6C Containment Debris Protection for ECCS Strainers

The information in this appendix of the reference ABWR DCD is subject to several changes due to the adoption of a complex ECCS strainer design (e.g. Cassette Type Strainer). Consequently, for clarity it is presented in its entirety with the following departures incorporated. This strainer design has been used at numerous BWRs in Japan and numerous PWRs in the United States. The strainer is described in this appendix. Departure STD DEP Vendor changes General Electric (GE) to Toshiba in Section 6C.1.

STD DEP 6C-1 (Figure 6C-1, 6C-2, 6C-3, 6C-4, 6C-5)

Figure 6C-1 Cassette Strainer Cutaway

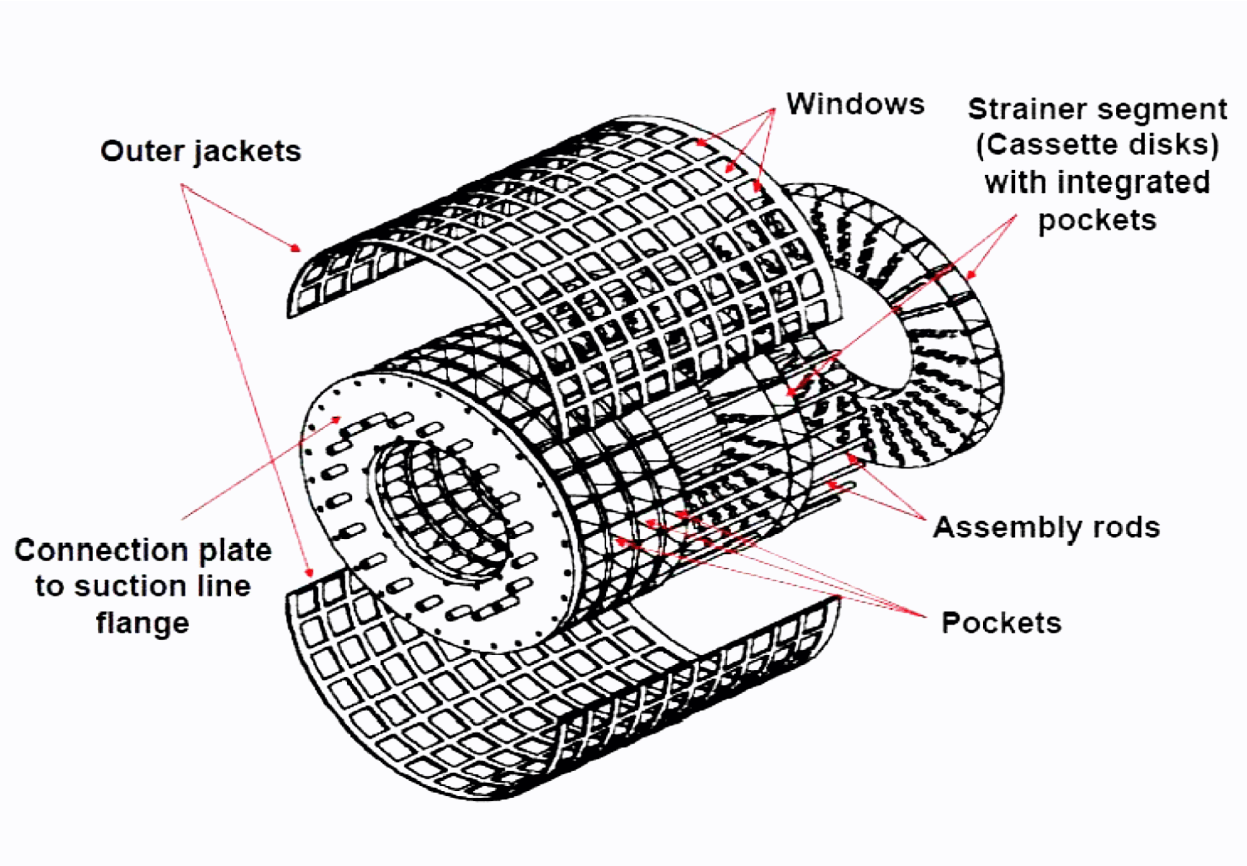
The suction strainers design *at* Perry preceded and *did not meet the current regulatory requirements. The ABWR ECCS suction strainers will utilize* ~~*a "T" arrangement with conical strainers on the 2 free legs of the "T"*~~ a cassette type strainer design. ~~*This design separates the strainers so that it minimizes the potential for a contiguous mass to block the flow to an ECCS pump.*~~ The design of the strainers will be based on Regulatory Guide 1.82, NUREG/CR-6224 (Reference 6C-4), NUREG/CR-6808 (Reference 6C-5) and the Utility Resolution Guidance, NEDO-32686-A. The cassette type strainer design is based on a set of cassette modules with U-shaped filter pockets attached to the cylindrical outer jacket. Each strainer consists of filter modules, the outer jacket and flange plates on each end of the cylindrical assembly. The filter module is constructed with cassettes which are arranged axially along the strainer axis. One cassette consists of pocket shaped filters which are arranged radially. A cut-away drawing of the strainer is shown in Figure 6C-1. The material used in the cassette type strainer is stainless steel. The cylindrical strainer assemblies are mounted in pairs on piping tees at each ECCS pump suction line. When the ECCS pump operates, the suction flow in the suppression pool runs into all pockets through the outer jacket windows. Each pocket has five flow paths from the inlet through the five perforated walls to the outlet of the pocket towards the cassette strainer. By using the cassettes with the pocket shaped filters, the strainer has an available filter area which is larger per volume than cylindrical and other shaped strainers. The number of cassettes and pockets is adjusted to produce a specific head loss performance for the strainer. To avoid debris clogging the flow restrictions downstream of the strainers, the size of the holes in the perforated sheets is chosen by considering specific paths of ECCS equipment and piping (for example, the containment spray nozzle and the ECCS pump seal cooling flow orifices). The STP 3 & 4 strainers will have holes no larger than 2.1 mm.

Figure 6C-2 Core Inlet Delta-P for Blocked and Unblocked Cases

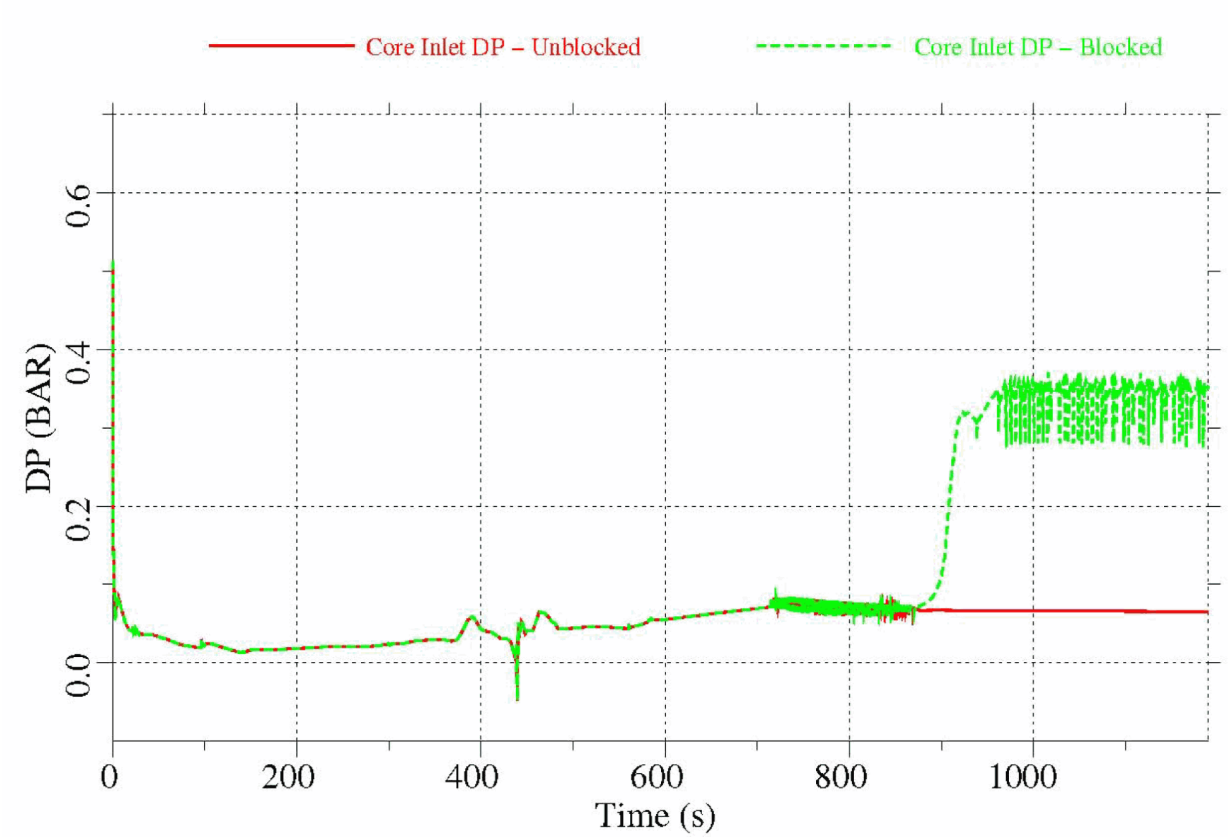
Figures 6C-2, 6C-3, and 6C-4 compare the core inlet DP, flow rate and void fractions for the cases with no blockage and with blockage resulting in a reduction of flow area by 90% of inlet flow area. Five minutes is the estimated amount of time required for debris in the containment to start to reach the fuel filters. The models assume clogging begins at 850 seconds because that is when the flow through the core reaches steady state. In order to ensure any effects seen are covered by the changes being made, steady state flow is required. Despite a very high level of blockage, sufficient flow remains available to the core to ensure that the core void fraction both in the hot assembly and average assembly remain < 0.95.

Figure 6C-5 Peak Clad Temperature for Blocked and Unblocked Cases

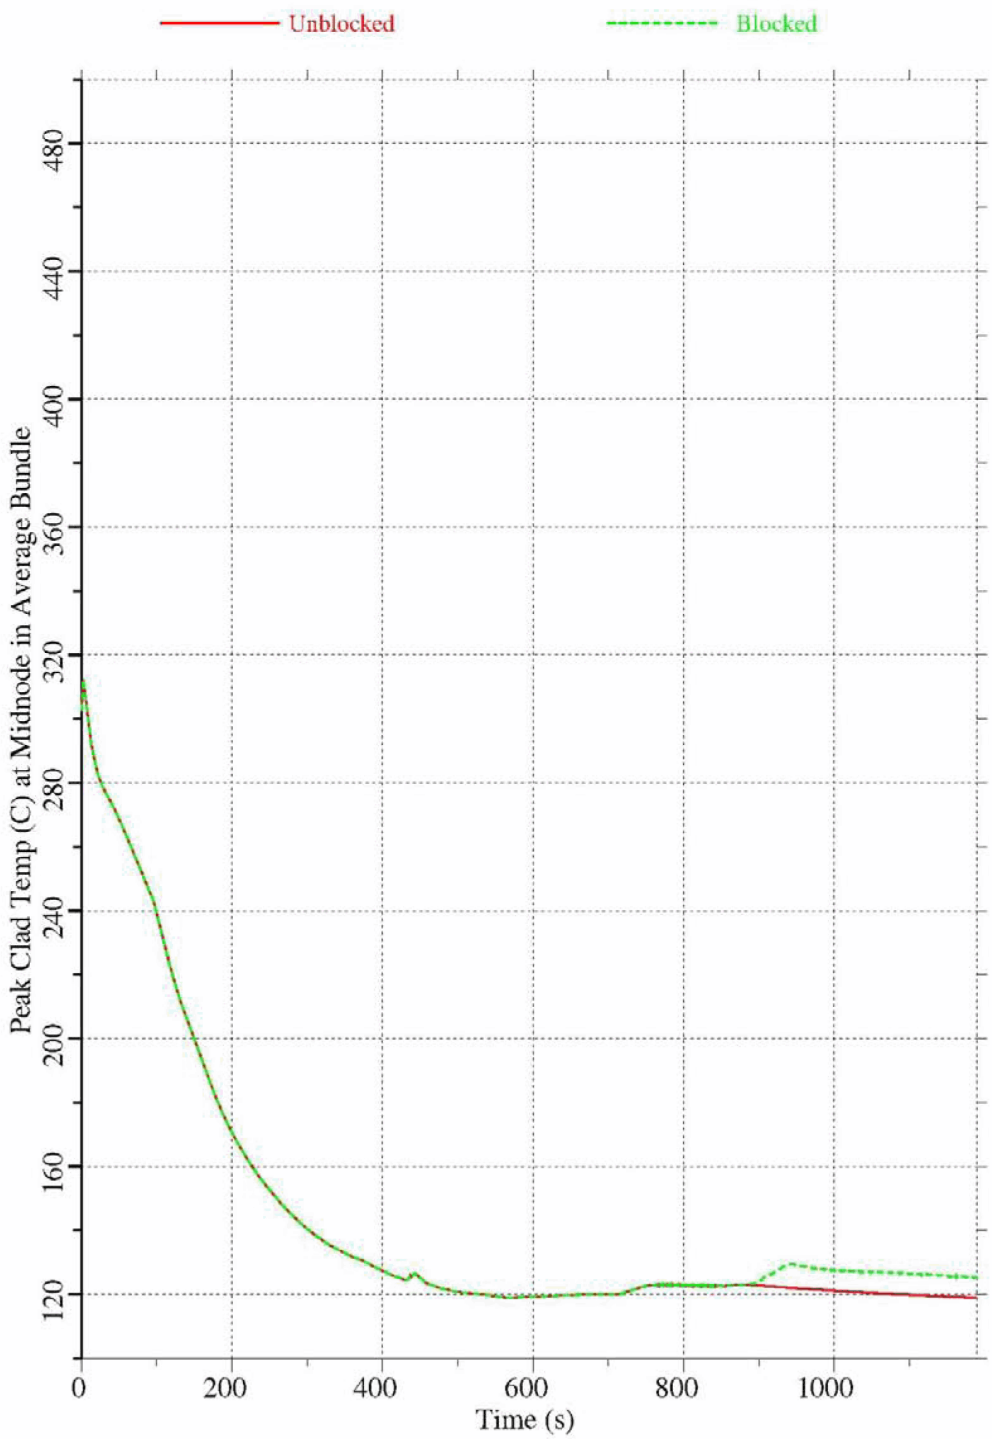
In the ABWR design, the peak cladding temperature (PCT) occurs very early in the transient during the Reactor Internal Pumps (RIPs) coastdown phase, before ECCS injection occurs. Therefore, the PCT remains unaffected during the RIP coastdown by the subsequent blockage at the fuel inlet because the cladding temperature is maintained low (near the saturation temperature) as the core void fraction, both in the hot and average assemblies, is maintained below < 0.95. Figure 6C-4 provides a comparison of cladding temperature for the blocked and unblocked cases. The low fuel clad temperature also ensures that cladding oxidation does not occur in the long term cooling phase of the accident.

The impact on the clad temperature of fouling caused by an assumed deposition of particulate debris on the cladding is small. The increase in PCT from low fouling to high fouling is only approximately 30 deg F.
